ASSESSMENT REPORT

M2 SITE, NORTH RYDE SSD 5093 MOD 2

Figure 4: Borrow Pit and level platform

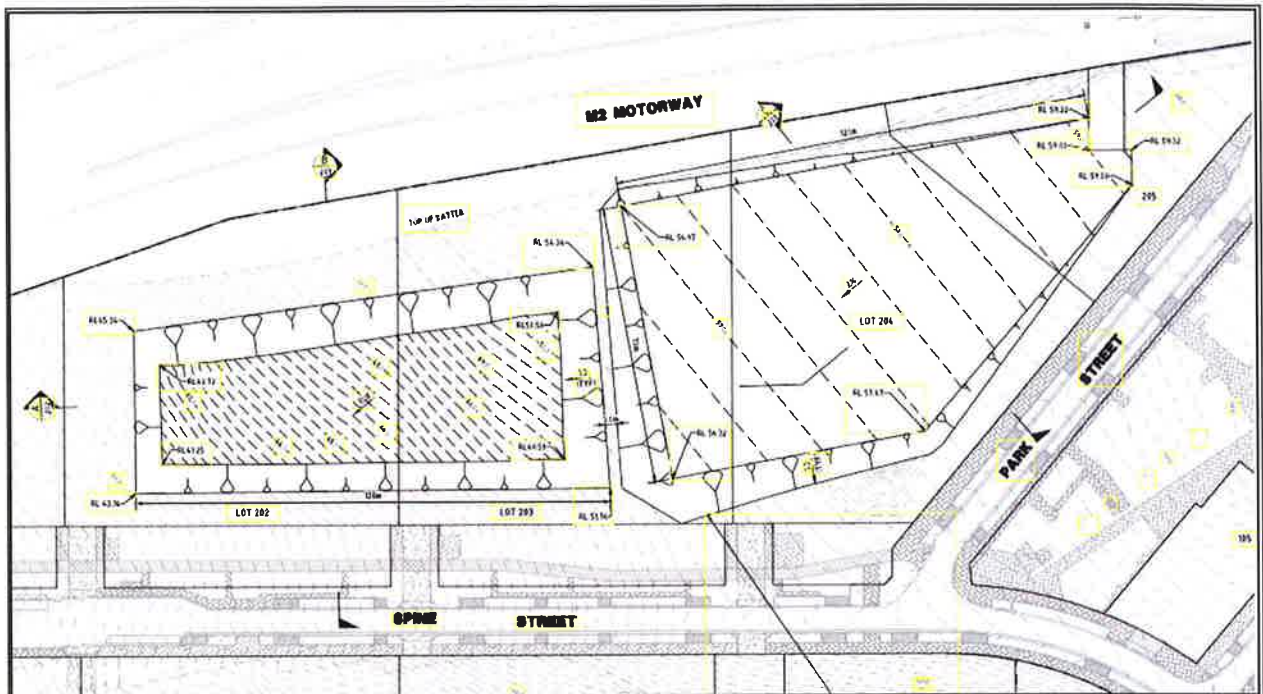
Issue	Consideration	Recommendation
<i>Earthworks</i>	<ul style="list-style-type: none"> A borrow pit excavated to a depth of approximately 3 m is proposed to facilitate a level platform for the assembly of the pedestrian bridge on the site. The proposed borrow pit would be located adjacent to the M2 Motorway in the eastern part of the site, and outside of the rail corridor. It would be filled back in to approved levels by 2018, unless it is to be utilised for basement construction, approved through a future Development Application. The DPI has recommended inclusion of an additional condition to manage impacts in the event that the groundwater table is intercepted during the excavation of the borrow pit. Although geotechnical investigations indicate ground water would be unlikely to be encountered (being located approximately 5 to 8 m below existing ground levels), the Applicant accepts the additional condition. The Department has therefore included a condition to ensure impacts are appropriately managed in the event ground water 	A new condition in relation to the borrow pit is included in the recommended modified consent.

- Otherwise, the Department notes there are existing conditions that would appropriately manage and minimise any impacts on the nearby rail corridor and to deal with soil and water management. The Department is satisfied the existing conditions are adequate to ensure environmental impacts are appropriately managed during the earthworks phase.

Figure 5: Bridge landing pad and amended subdivision layout

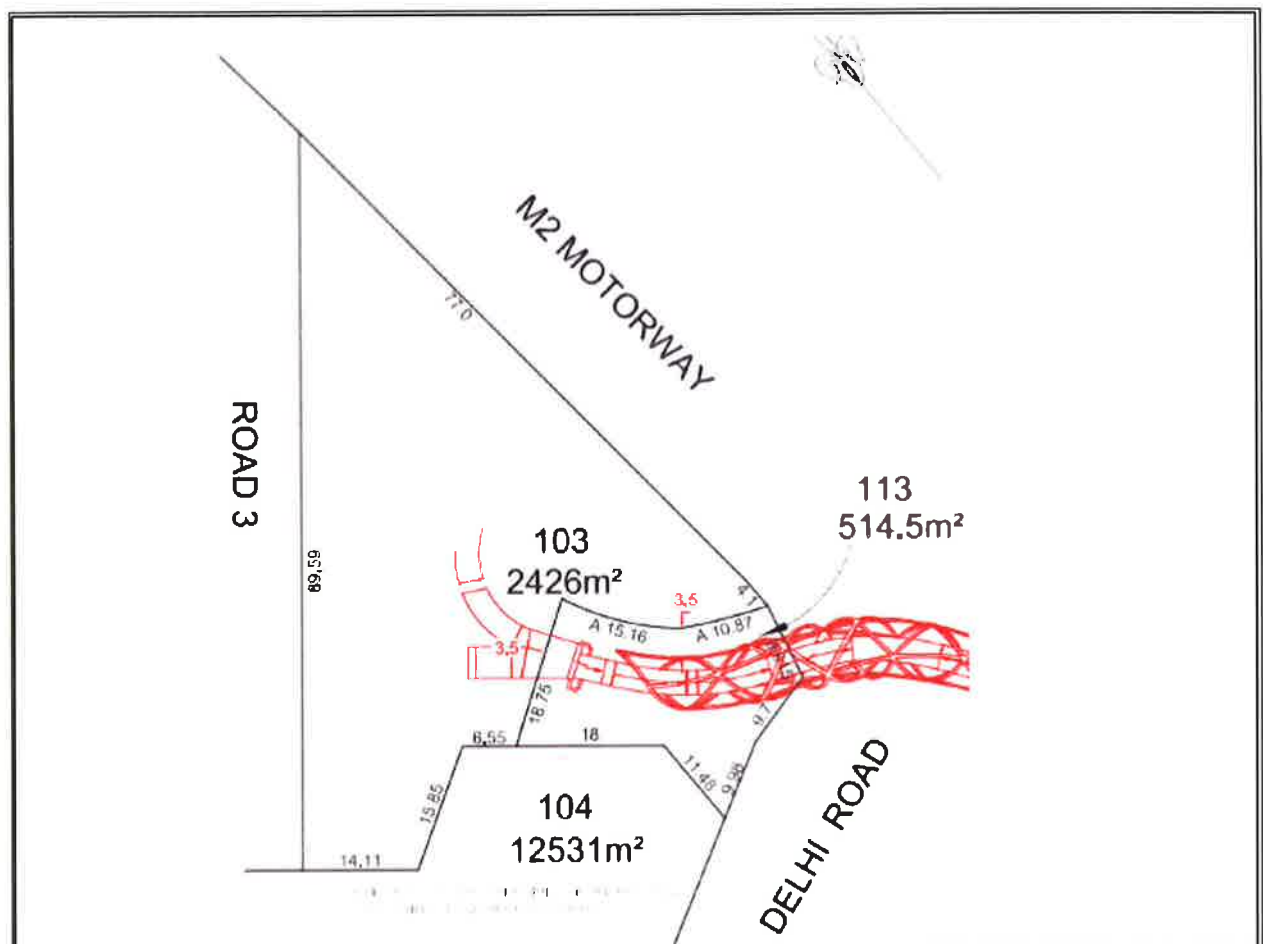
<i>Security bonds</i>	<ul style="list-style-type: none">Introduce a new condition to enable the provision of a security bond for any incomplete works at the time of the subdivision certificate being issued in accordance with the bonding arrangements in the draft Planning Agreement.
<i>Subdivision Plans</i>	<ul style="list-style-type: none">Reduce the size of Lot 103 (a future park and currently designed to including the landing pad for the pedestrian overpass bridge) to include a new lot known as Lot 113 with an area of 435 sqm to accommodate the bridge landing pad,

to be transferred to RMS as part of the public road. The revised subdivision is shown in **Figure 5**.

Roads and Maritime Services (RMS) does not object to the proposal, but recommends the inclusion of a new conditions regarding the dedication of the land on which the pedestrian bridge is located as public road. The RMS has no concerns with the proposed change to the timing for completion of intersection roadworks.
